TRANSPORTATION ENGINEERING DESIGN STANDARDS (TEDS) **DRIVEWAY DESIGN EXCEPTION REQUEST**EL PALOMINO MOTEL ADDITION March, 2009

Project Number: **TED-2009-077**

Primary Project: PRE-2009-009 - El Palomino Motel Add'n

TEDS Exception Request #1: TEDS 3.2.4 – Request to allow two existing accesses on North Avenue to remain.

Exhibit B – Proposed Condition

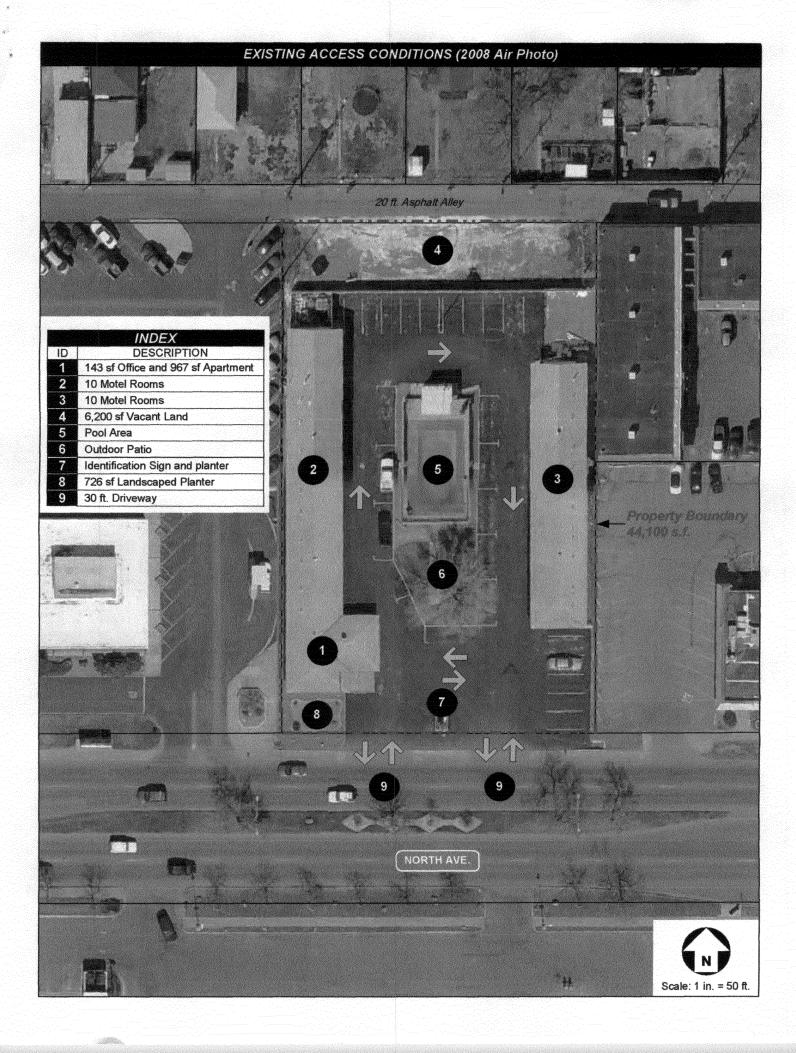
The day-to-day operations of the proposed expansion of this motel can be adequately served by a single access. Additionally, closure of one access will help accommodate the recently adopted North Avenue Corridor Plan, which states the following:

"Fire Prevention would not be in favor of closing either of the existing driveways. The existing property exceeds the 150 foot rule without a turnaround which for the existing location would be acceptable. If either of the driveways were to be eliminated it would require us to cross over the existing pool area for firefighting and or ambulance access. If the East entrance were to be closed and parking were allowed as shown a fire truck would not be able to enter the area around the office canopy. The alley on the North would allow for a fire truck however we would use it only as protection for the single family dwellings to the North."

Chuck's comments significantly change the nature of this TEDS Exception. I don't see any way to close an access AND resolve Fire's concerns, it appears that we are forced to approve the request. I think we need to meet again to discuss this further.

Fire Prevention would not be in favor of closing either of the existing driveways.

The existing property exceeds the 150 foot rule without a turnaround which for the existing location would be acceptable. If either of the driveways were to be eliminated it would require us to cross over the existing pool area for firefighting and or ambulance access. If the East entrance were to be closed and parking were allowed as shown a fire truck would not be able to enter the area around the office canopy. The alley on the North would allow for a fire truck however we would use it only as protection for the single family dwellings to the North.

The TED's Exception Committee has approved your request as submitted.
